VE Study Report

I-25 Operational Improvements Colorado Springs, CO

Subject: I-25 Operational Improvements, Fillmore to Garden of the Gods
Colorado Springs, CO
VE Study Report

Sketch of Baseline—Typical Single Lane Closure

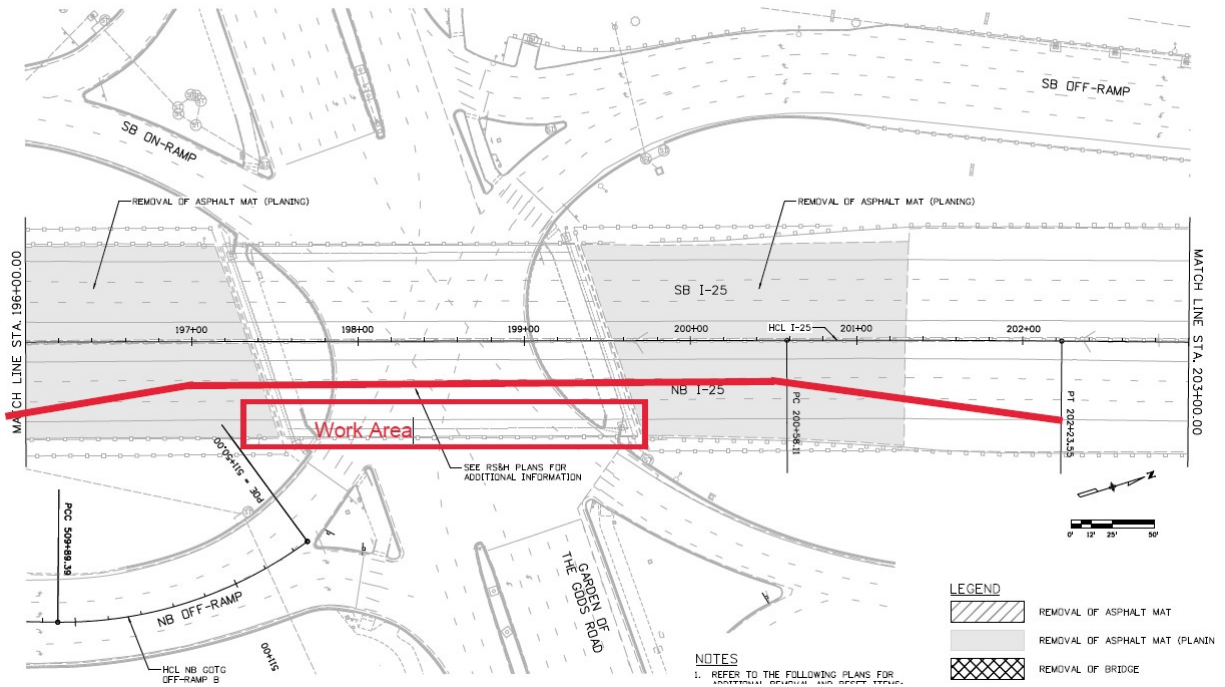
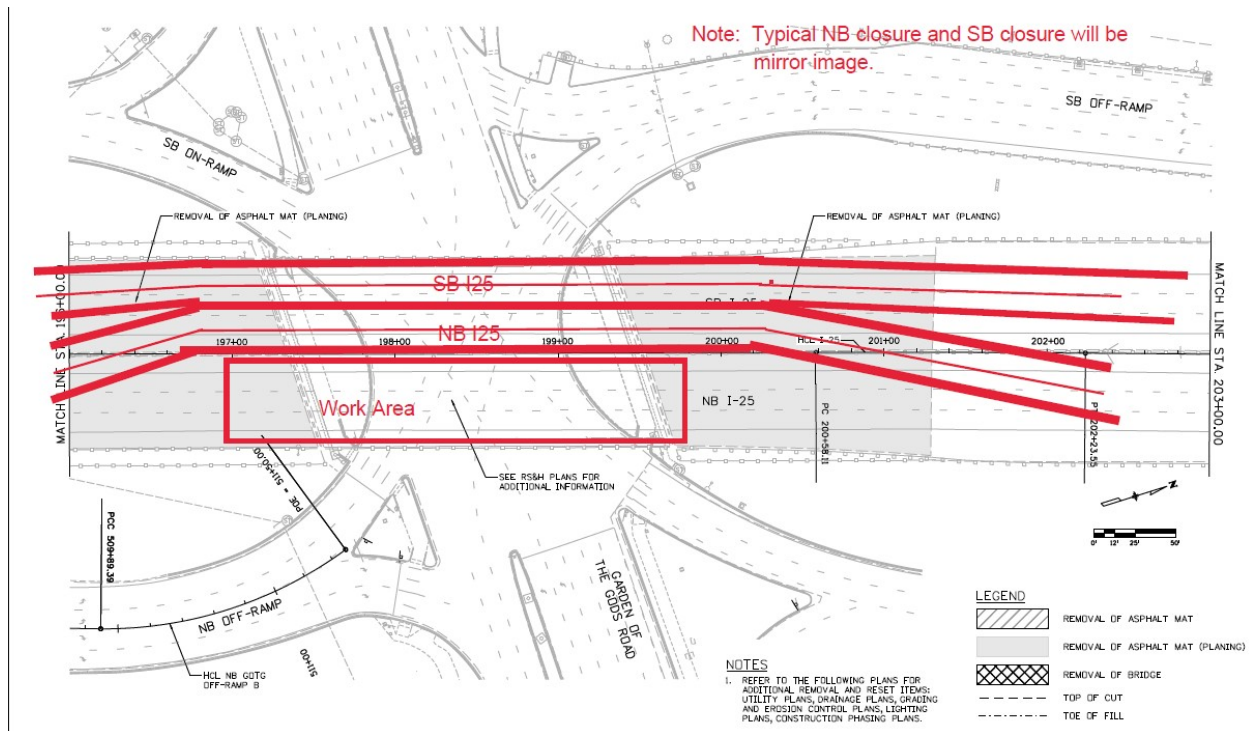
Remove 243 linear feet of the existing expansion device and replace it with 243 linear feet of bridge expansion device (0-4 Inch) at both northbound (NB) and southbound (SB) GOG Bridge on Interstate 25. This work (remove and replace) will be performed at night, one lane at a time.

Perform removal and replacement of bridge expansion joint for both NB and SB GOG Bridge over a weekend.

Performing removal and replacement of expansion joints over a weekend makes good sense. With placement of both NB and SB traffic on either NB or SB, depending on which side the contractor is working, the contractor can pull all their resources to complete the work over the weekend. This method would reduce the maintenance cycle of header and the expansion joint itself, reduce the construction duration by more than 20 days, and more likely result in smoother transitions from the roadway to the bridge.

This proposed approach would take place over two weekends and is highly recommended by the VE team.

Sketch of Baseline—Current Super Correction Phase 8 (Night and Day)

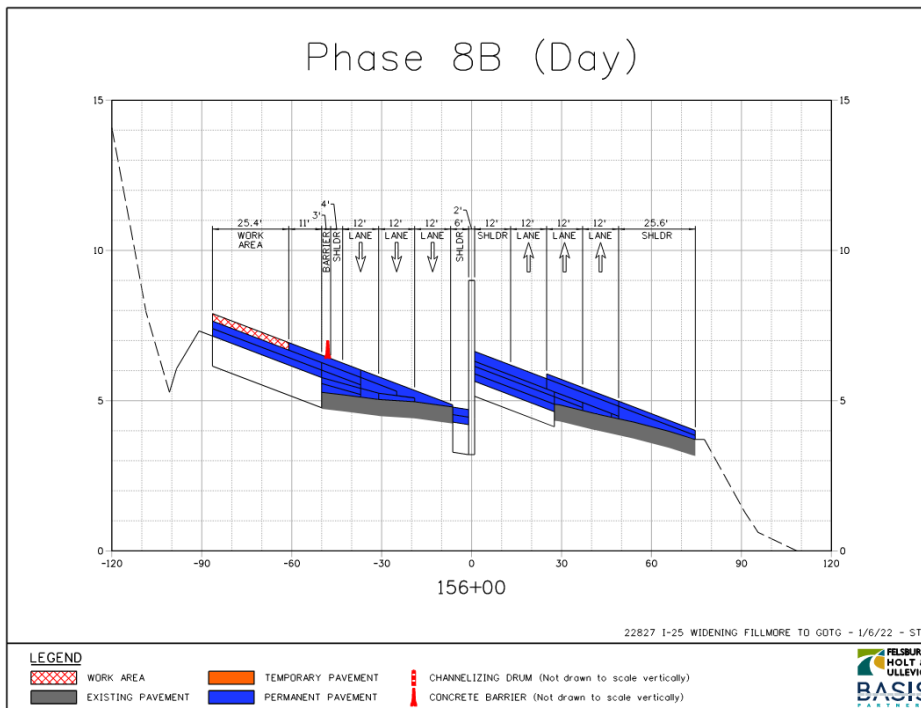
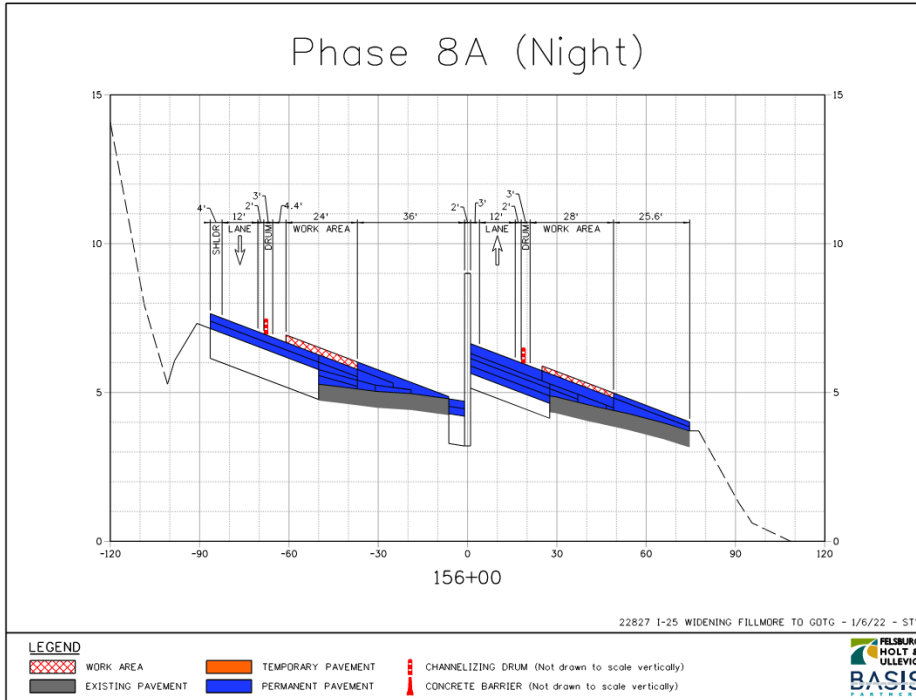
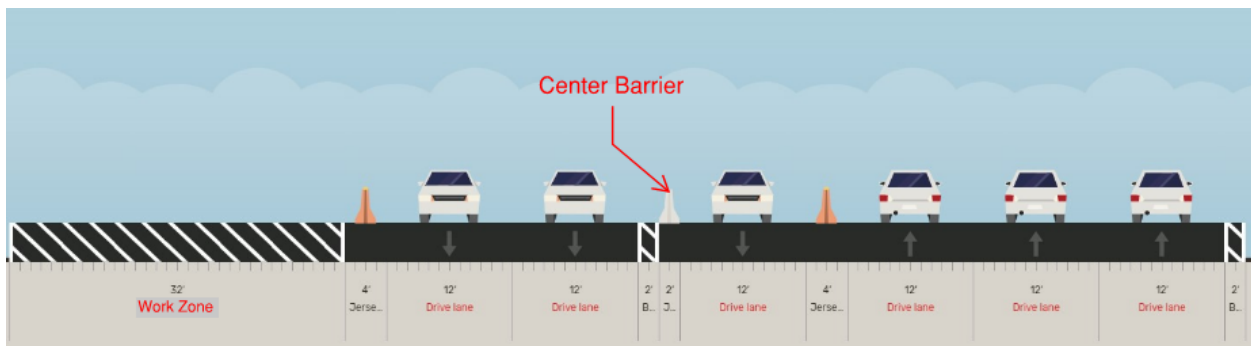
Construction phasing and construction traffic control are currently based on set-up and take-down of traffic control devices between day and night work, limiting the time actual work may be performed.

Split traffic lanes in the same flow direction (northbound [NB] or southbound [SB]) to allow for work zones that can be left open for multiple days or weeks. This may include staying on the current side of the roadway or splitting a lane off into the opposing travel direction side of the highway, for example, pulling one SB lane into the western edge of the NB direction and separating by barrier.

The current approach for the superelevation correction in the FIR Plan Set Construction Phasing Plans requires challenging and time-consuming shifts in the traffic control devices between day and night work. The night shift is controlled by CDOT’s lane closure policy and will be limited to approximately 10:00 p.m. to 5:00 a.m. Productivity during night work will be limited to the small window after devices are set up and before they need to be taken down to reopen for morning traffic. As a result, we are proposing to split the traffic lanes to open work areas for extended periods of time and minimize the resetting of traffic control devices.

The proposed approach is frequently used on projects and would be beneficial in areas requiring a superelevation correction, specifically the full-depth replacement areas. Full-depth pavement replacement isn’t feasible to accomplish in a single overnight operation and open the next day to traffic. Allowing the contractor to keep a work area open for multiple days or weeks will enable them to spend less time shifting traffic patterns and associated traffic control devices, thereby increasing productivity and reducing the construction duration.

Sketch of Proposed Change—Bridge Slide Example

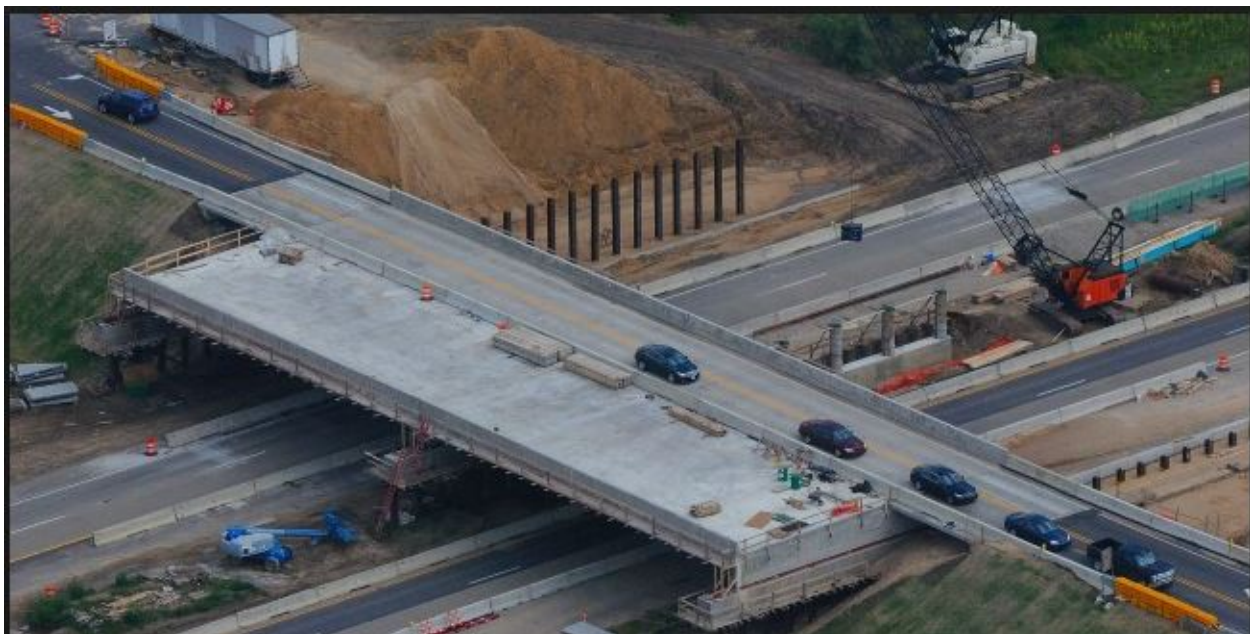
The planned approach is to use phased construction for the construction of the Ellston Bridges.

Allow the contractor to use a bridge slide or other form of offsite bridge construction by encouraging innovation in the advertisement for construction.

Using a conventional bridge construction technique requires removing the west ten feet of the existing structure. Using a slide-in method, this step can be eliminated. Slide-in bridge construction allows traffic flow by keeping the existing bridge open to users, while the new bridge-building occurs. Allowing traffic flow is the most significant advantage compared to conventional bridge construction. Slide-in bridge construction builds the replacement bridge on a temporary support structure. Some replacement bridges are built off-site and shipped to the temporary support location. The contractor builds the substructure and the new superstructure simultaneously. In some cases, the abutment is also built under the existing bridge.

Figure 1: Baseline Bridge Separation

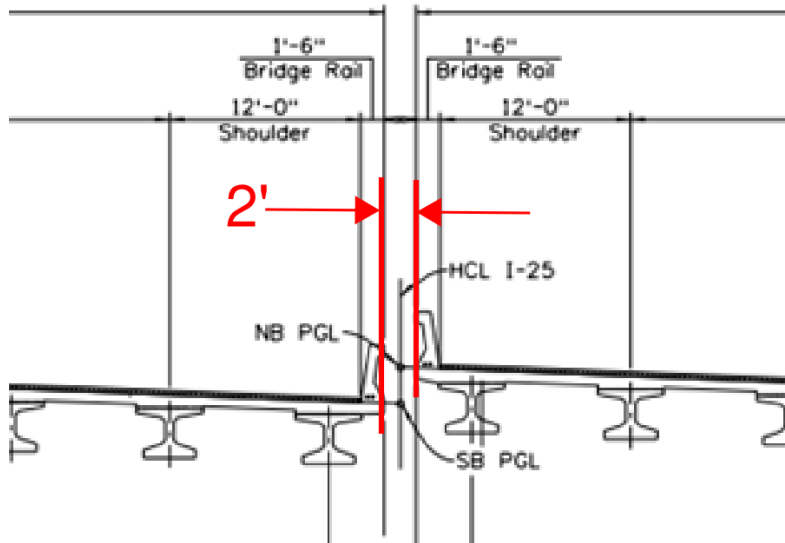
The current design plans show a two-foot separation between the proposed I-25 bridges over Ellston Street. It has been discussed that this minimal clearance will make it difficult to construct the bridges in phases, which is needed to stage construction for this project. **Figure 1** on the following page depicts a portion of the proposed typical section for the bridges.

Only 2 feet of separation would make it difficult to maintain the bridge rails. A 5-foot clearance will allow for much easier access from below.

Ultimately, the benefits to separating the bridges to at least a five-foot separation greatly outweigh the design changes necessary.

Sketch of Proposed Change

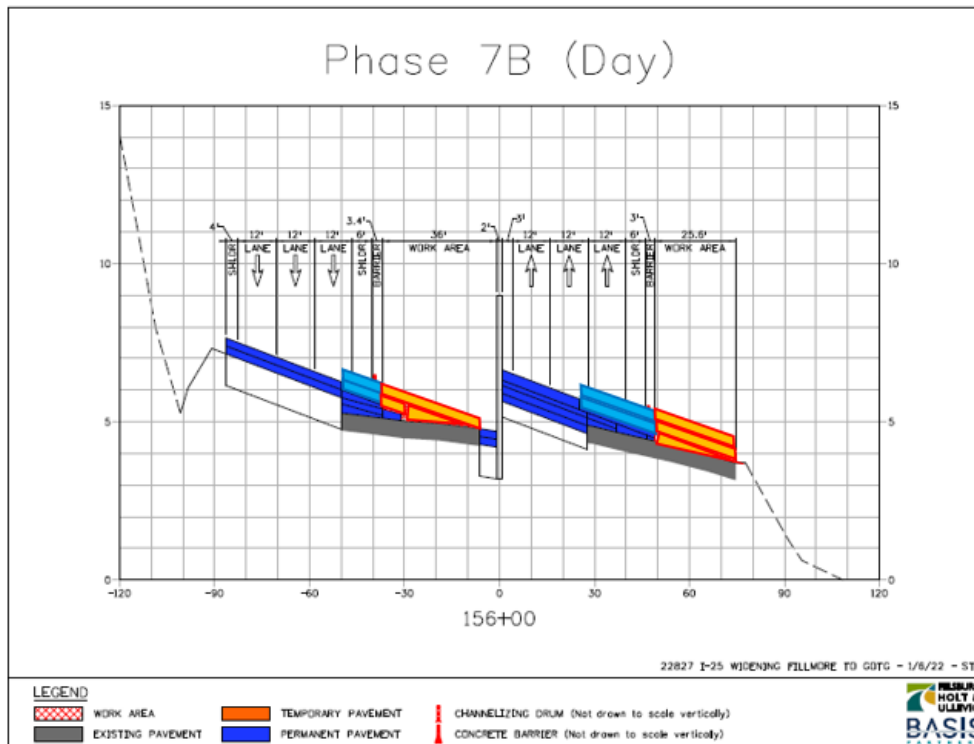
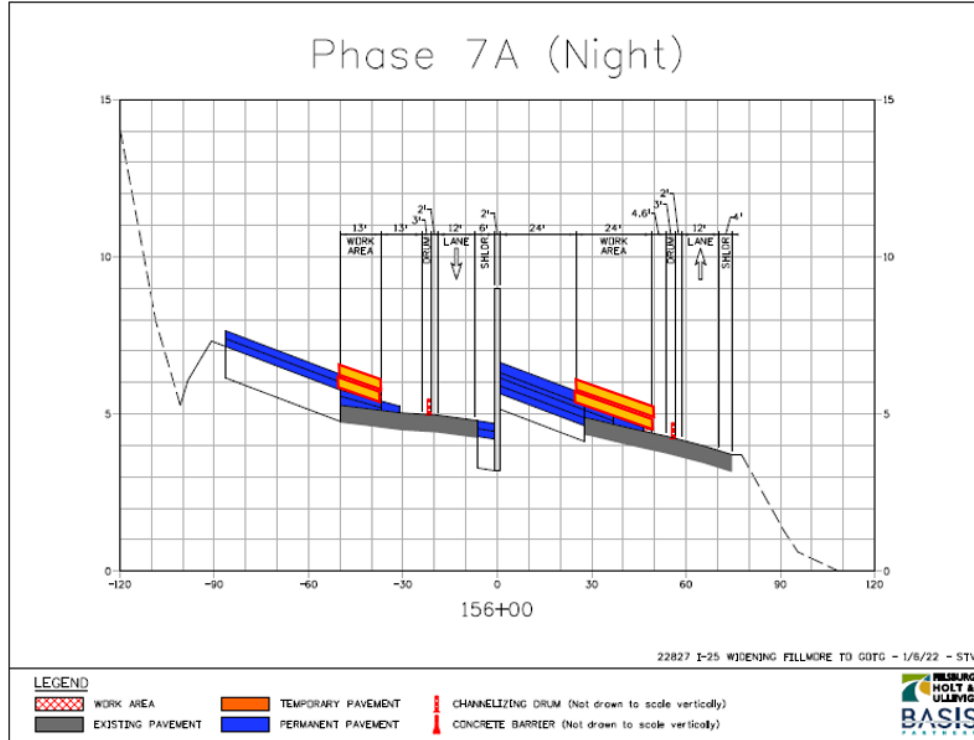
Increase the design thickness of both the pavement lifts and the temporary longitudinal joints during construction within the superelevation correction area.

This project should benefit from a minimum increase to 4 inches for temporary longitudinal pavement joints *and* lift thicknesses, as this would be a theoretical 33% increase for thickness installed per lift and between traffic reconfigurations. This could eliminate extra paving phases and reduce the number of joints in the pavement structure, thereby improving the durability of the roadway.

The current paving plan calls for longitudinal joint thickness of 3 inches and other projects have gone further. It would be ideal for the proposed joint thickness to align with the design lift thickness (1x or 2x), so either a 4-inch (1x4" lift) or 6-inch (2x3" lift) joint thickness seem reasonable. Going beyond a 6-inch joint thickness may cause the taper width of the longitudinal joint to encroach too far into adjacent lane space and would potentially create a non-traversable joint.

Sketch of Proposed Detours

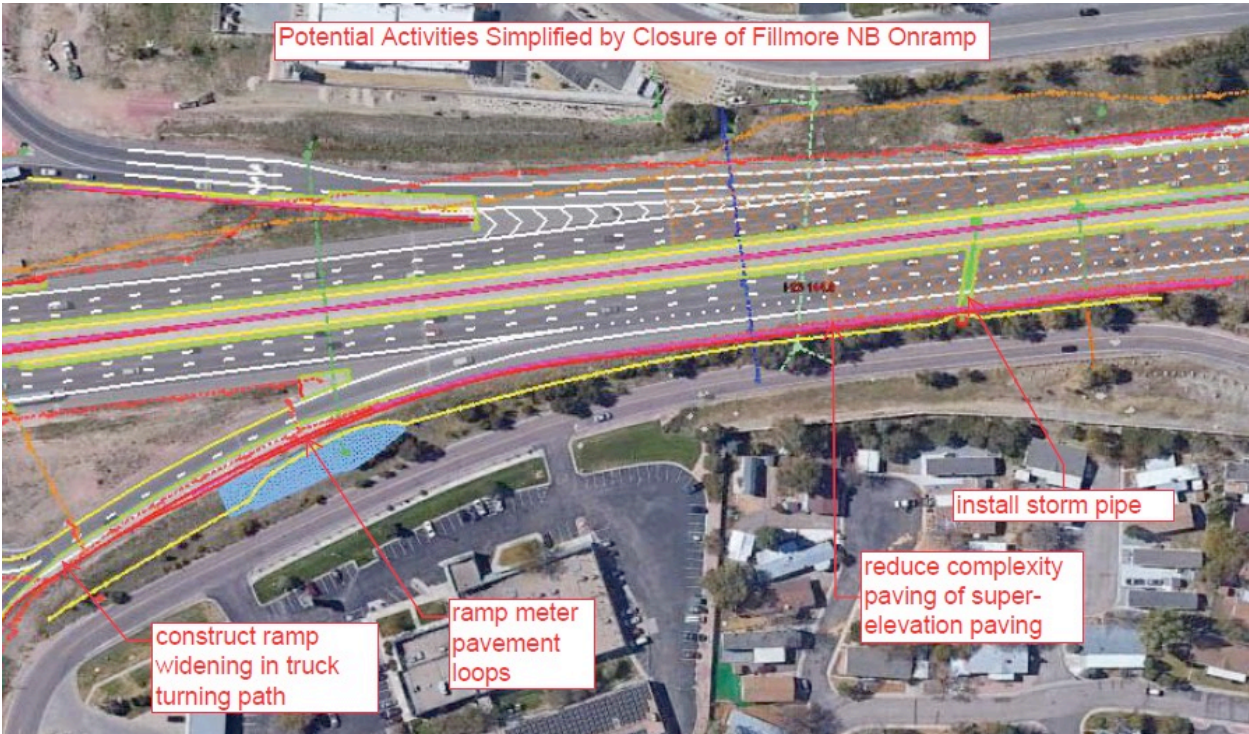
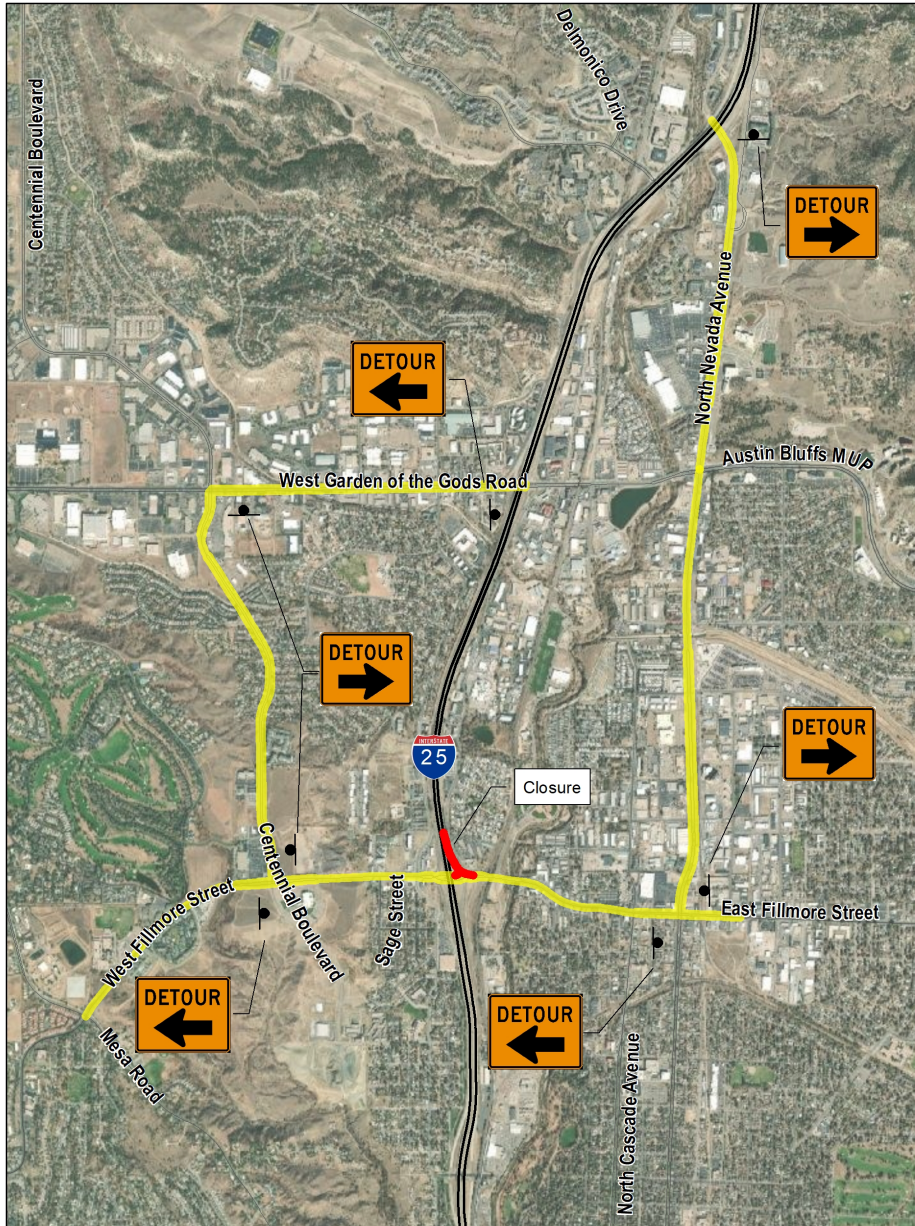
Moving the crossover further south would open the full width of I-25 North for superelevation correction, pipe crossings, and other construction activities. One of the primary constraints to the proposed crossover location is accommodating the merging traffic from the NB Fillmore on-ramp prior to the crossover. Closing the ramp would eliminate this constraint and allow the contractor flexibility in construction phasing.

Being able to construct the full width of NB I-25 without traffic would improve the quality and production rate and reduce the overall project schedule. Additionally, the widening of the NB Fillmore on-ramp and relocation of the ramp metering signals could be completed during the ramp closure. This would eliminate work occurring adjacent to moving traffic on the ramp and shorten the duration of time it would take to complete ramp construction.

The detours required by the ramp closure could include North Nevada Avenue to the east and Centennial Blvd. to the west. See sketches on the following page. Variable message signs will be needed to inform the public of the closure several weeks in advance and throughout the closure.
